A1 Birtley to Coal House

7.5D Statement of Common Ground: Historic England

STATEMENT OF COMMON GROUND: HISTORIC ENGLAND

Regulation Number:	Rule 8 (1) (e)
Planning Inspectorate Scheme Reference	TR010031
Application Document Reference	TR010031/7.5D
Author:	A1 Birtley to Coal House Project Team, Highways England

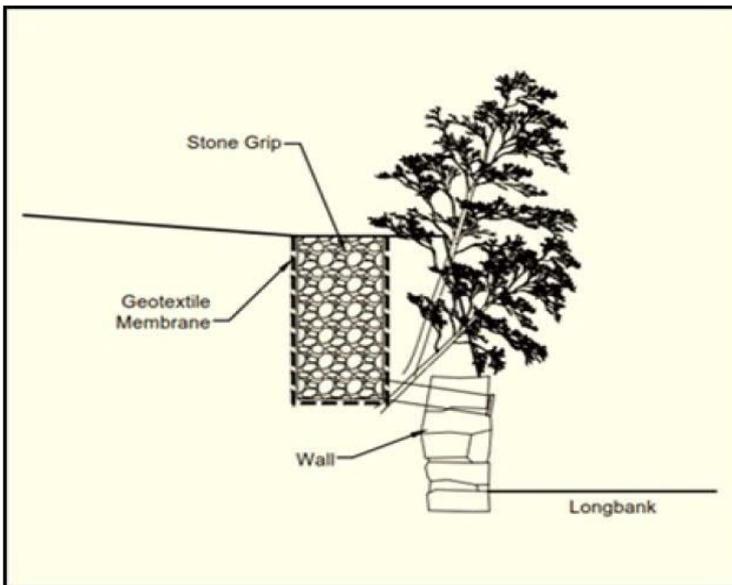
ITEM	SUBJECT	ACTION	DUE
	<p>Drainage grip behind the retaining wall</p> <p>The sketch detailing the drainage grip behind the retaining wall provided by WSP via email on 15 May 2020 was discussed.</p> <p>3 ■ questioned how much water would be expected to travel through and the expected associated damage to the wall. ■ discussed that the responsibility for future maintenance of the drainage would be Highways England.</p> <p>Action: ■ to clarify with the drainage engineers the level of water that would be expected to go through the wall and what impact the water would have on the wall.</p>	■	01 June 2020
	<p>Outline CEMP [CH2]</p> <p>4 N ■ discussed the wording of “substantially in accordance with” in [CH2] of Table 3-1 REAC the Outline CEMP. It was discussed that Historic England will be consulted on the final WSI and any should Historic England have any concerns that these would be raised with the Secretary of State (SoS). She further discussed that the Scheme will need to demonstrate that any changes to the documentation i.e. in the final CEMP and WSI, do not cause any worsening of effects and that Highways England has an “evaluation of change” process that ensures this is the case. ■ discussed that this wording would remain unchanged in the Outline CEMP being submitted at Deadline 6 (19 May 2020).</p> <p>Action: ■ to seek guidance from Historic England’s legal advisor on this wording.</p>	■	01 June 2020

I have also provided below the likely detail of the drainage grip behind the retaining wall for your information / further discussion.
